**CBD RAIL LINK (ZONE B – TUNNEL) – 175-177 CLEVELAND STREET AND 1-5
WOODBURN STREET, REDFERN (SSD 15_7064)**

Attachment A

CBD Rail Link (Zone B – Tunnel)

Drawings 482749-281 Rev 1 and 482749-281 Rev 1

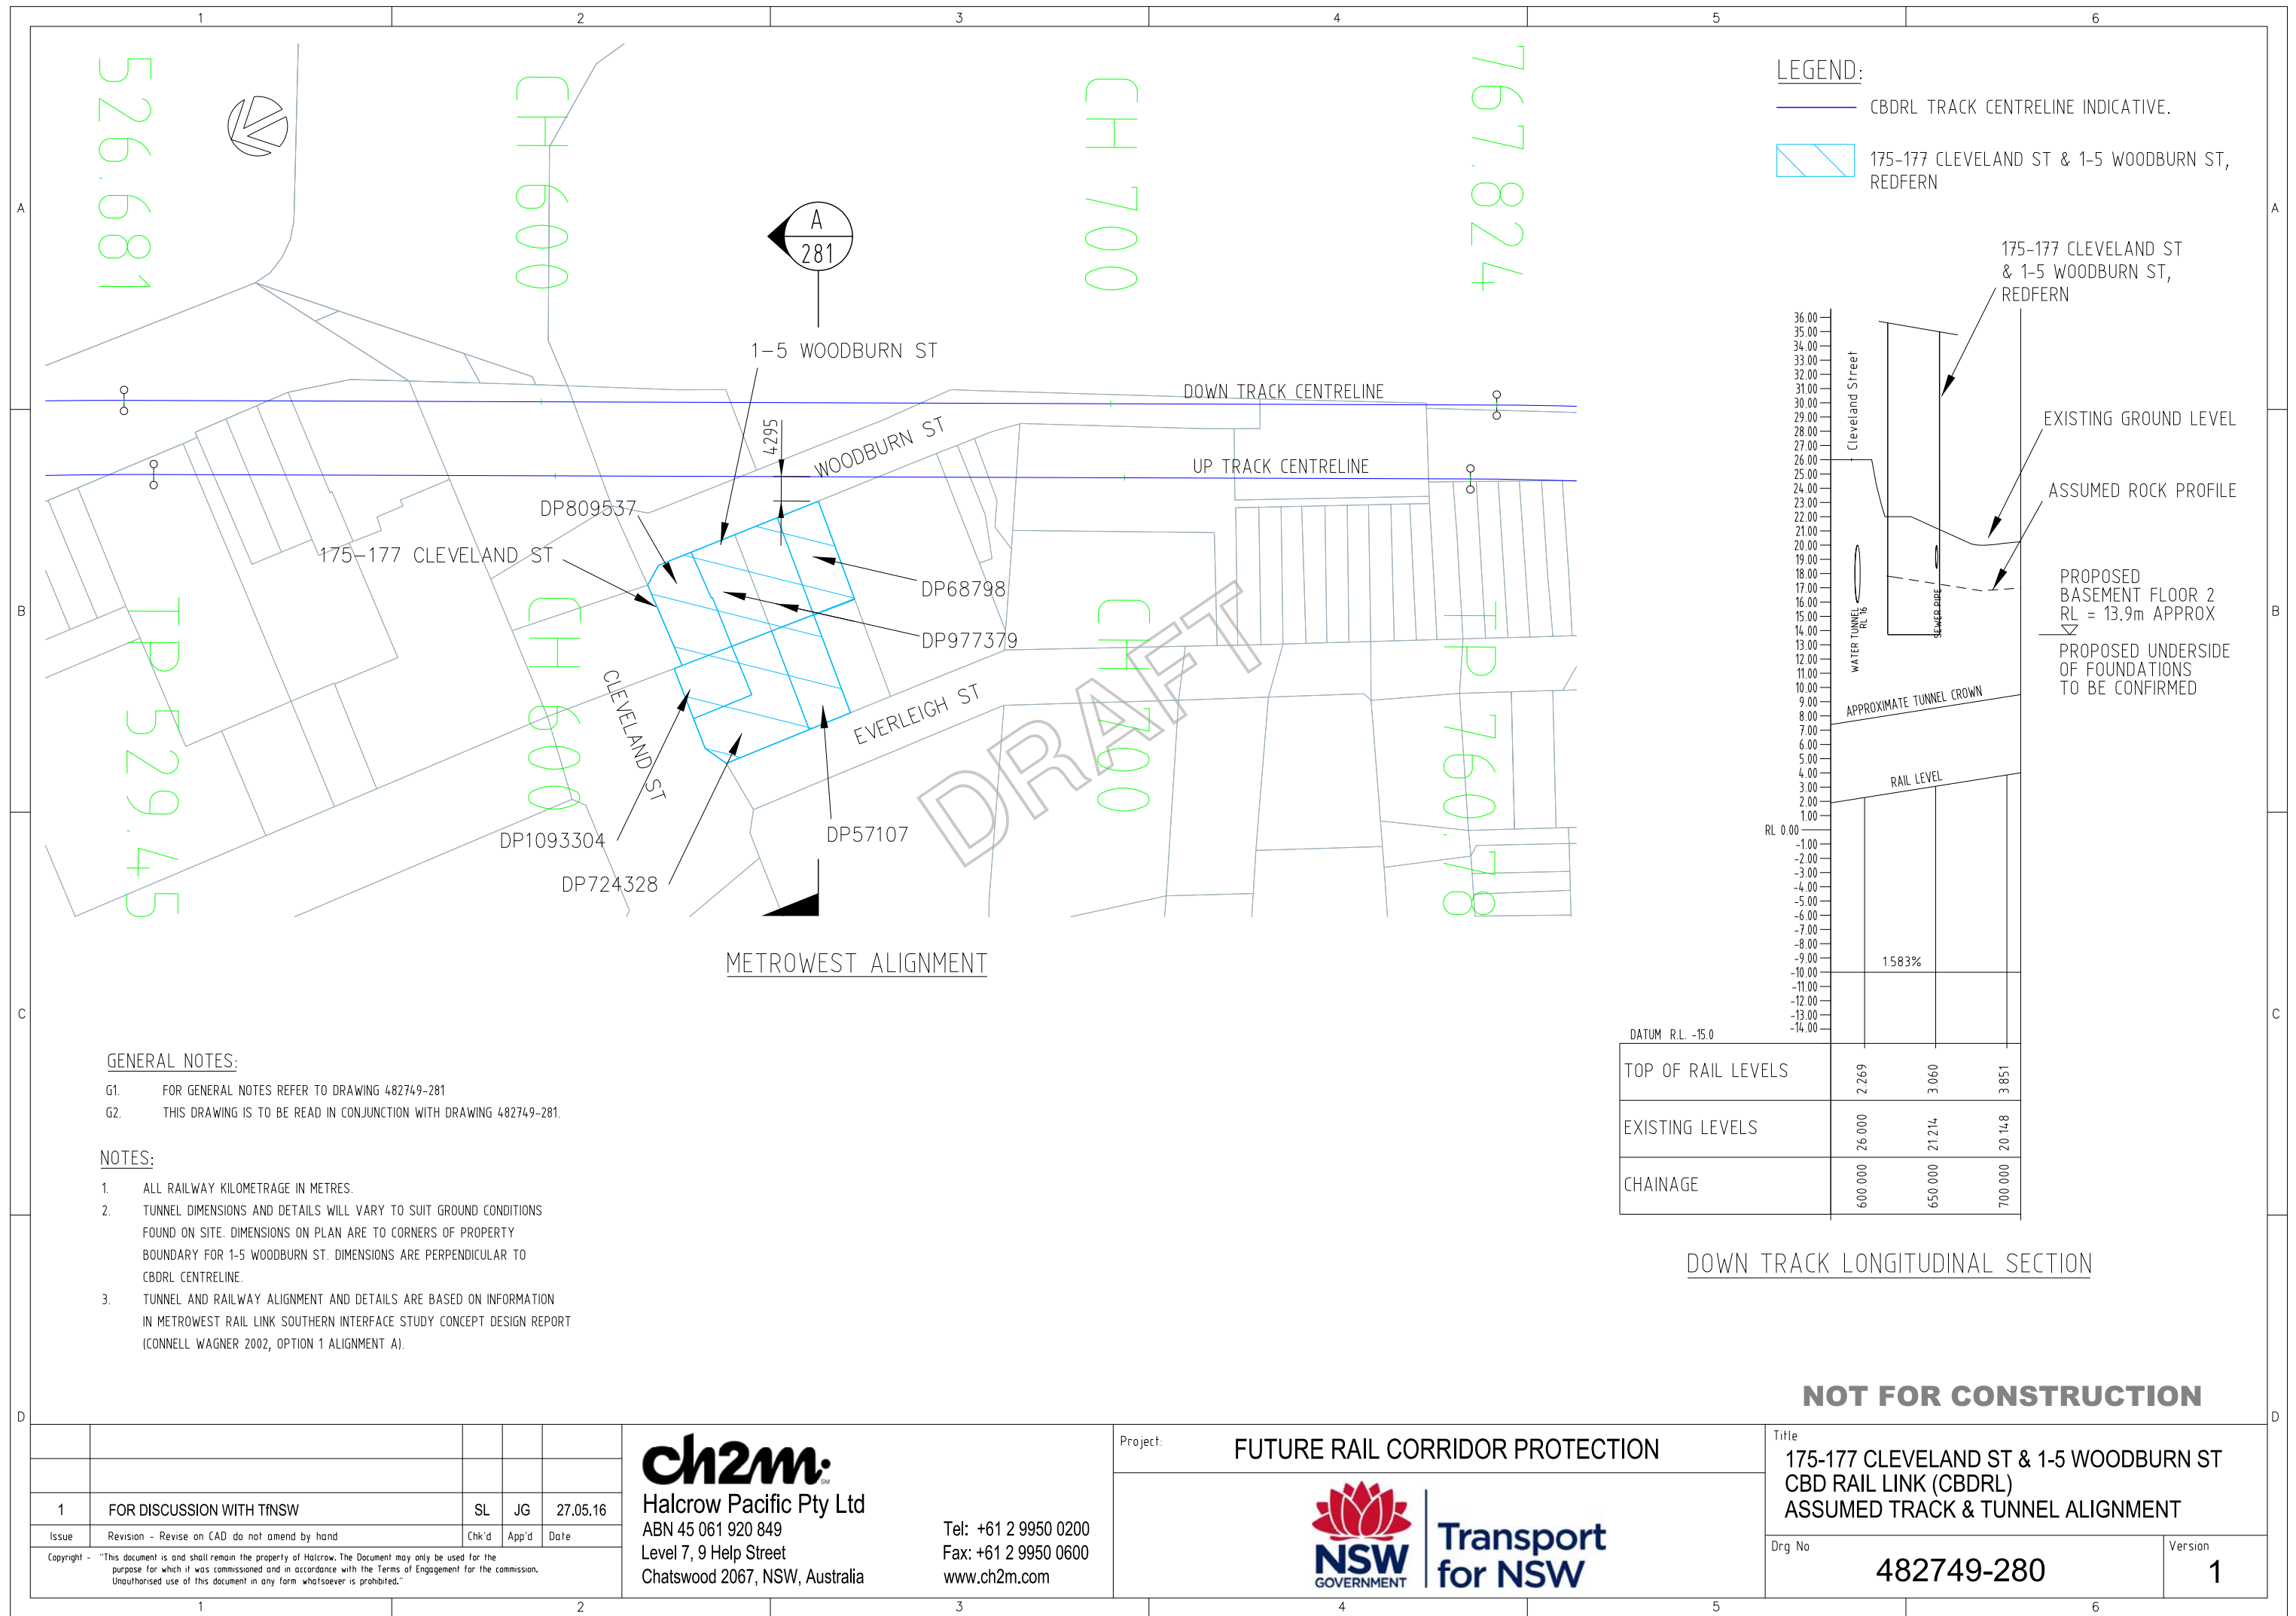
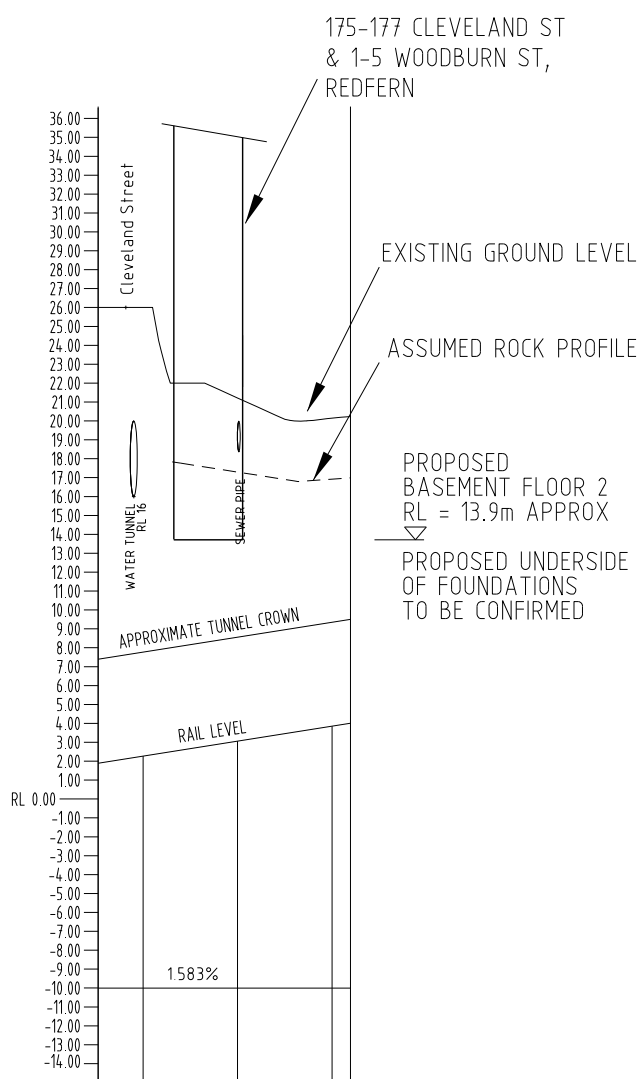
- b. The design and construction of the basement levels, foundations and ground anchors for the approved development are to be completed to the satisfaction of TfNSW. The developer shall develop their foundation design, and any encroachment into Exclusion Zones 4 and 5 must comply with the limitations of the Structure Exclusion Zones as indicated in drawing 482749-281 Rev 1. Cross sectional drawings showing the proposed basement excavation and structural design of sub ground support adjacent to the rail corridor should be included for the proposed foundations. All ground anchors and rockbolts within the CBDRL protection zone adjacent to the bulk excavation face shall be temporary anchors, of removable type or fibreglass type, to avoid obstruction of any future CBDRL construction.
